Nuclear Fuel Services, Inc.
P.O. Box 337, MS 123
Erwin, TN 37650

21G-03-0043
GOV-01-55-04
ACF-03-0053

February 14, 2003

Subject: Additional Commitments Regarding Licensing of the Uranyl Nitrate Building

FIGURE 1: BLEU Complex Site Plan

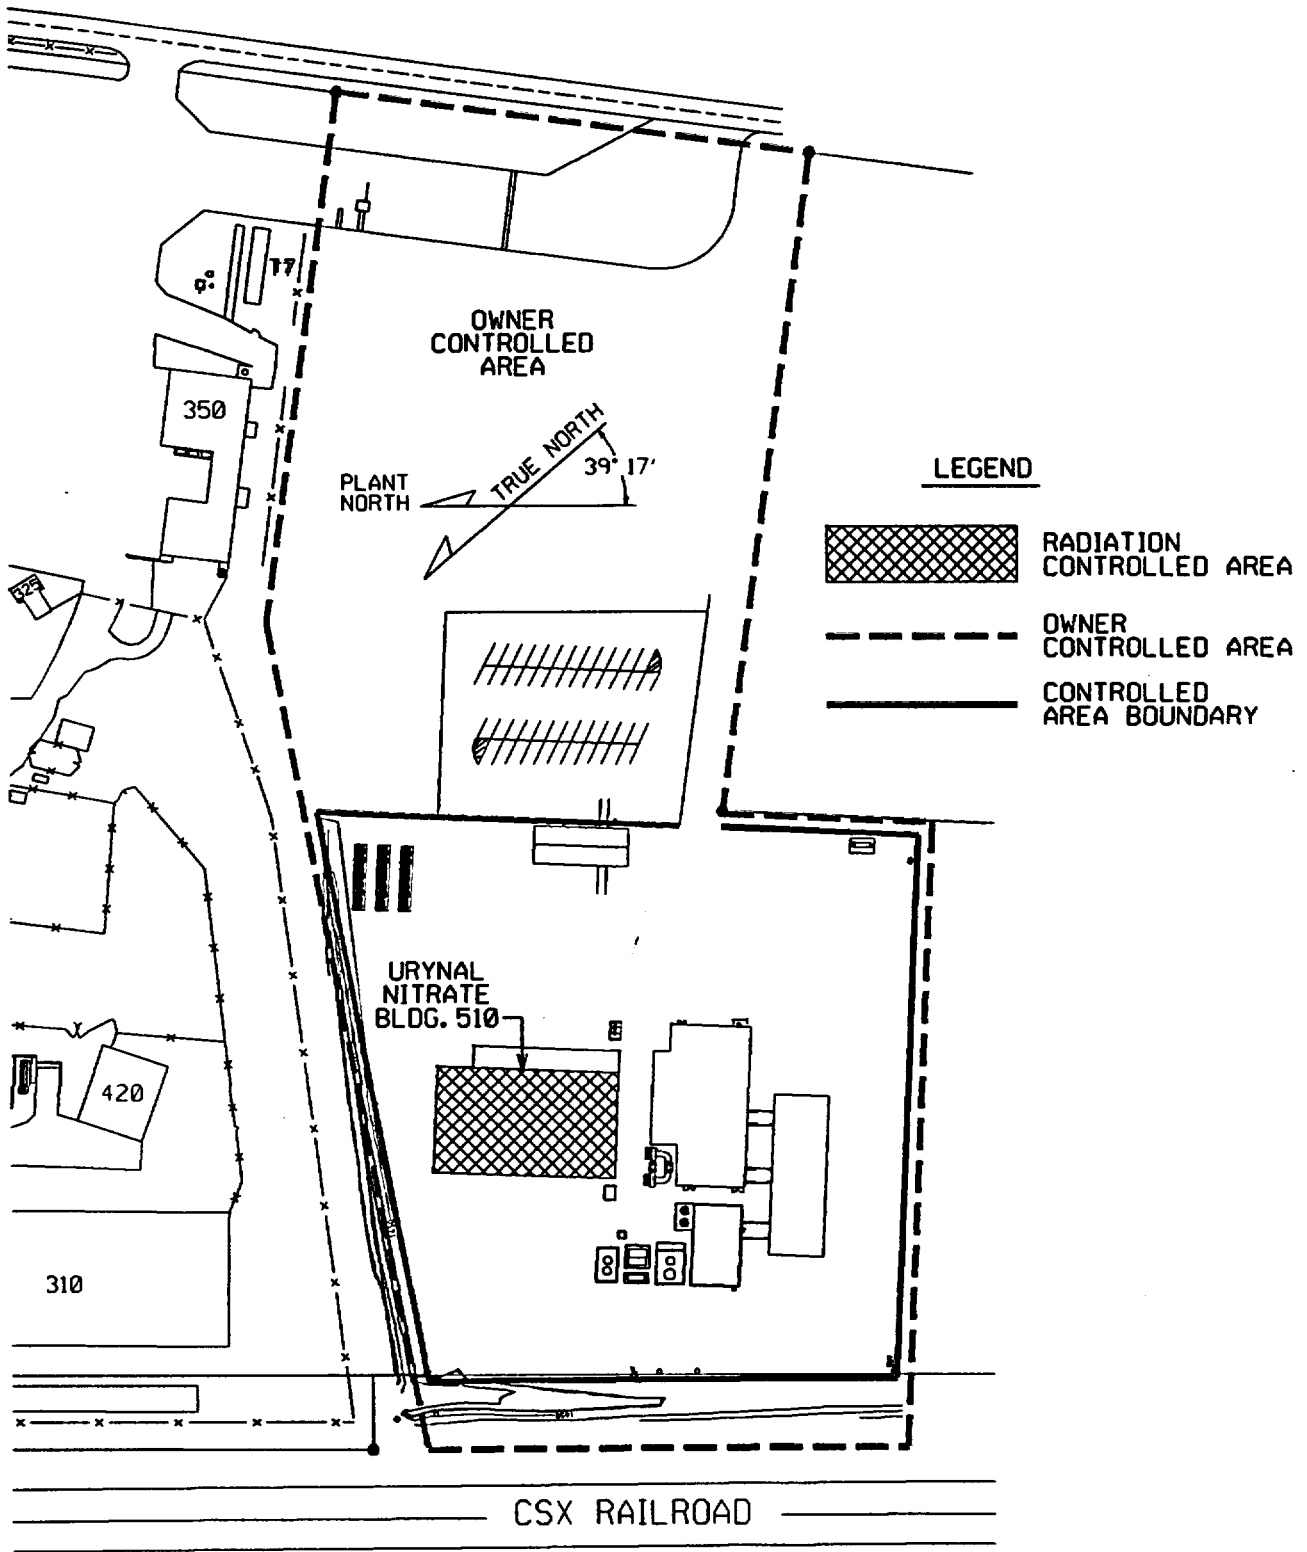
NFS commits to include a revised drawing that identifies the "Controlled Area Boundary" and the "Owner Controlled Area" located at the BLEU Complex. This revised drawing is included in Attachment III. Please note that the "Controlled Area Boundary" (described in 10 CFR 70.65(b)(2)) identified on the site plan is equivalent to a "Restricted Area" as defined in 10 CFR 20.1003 and in Chapter 1, Section 1.7.18, of SNM-124.
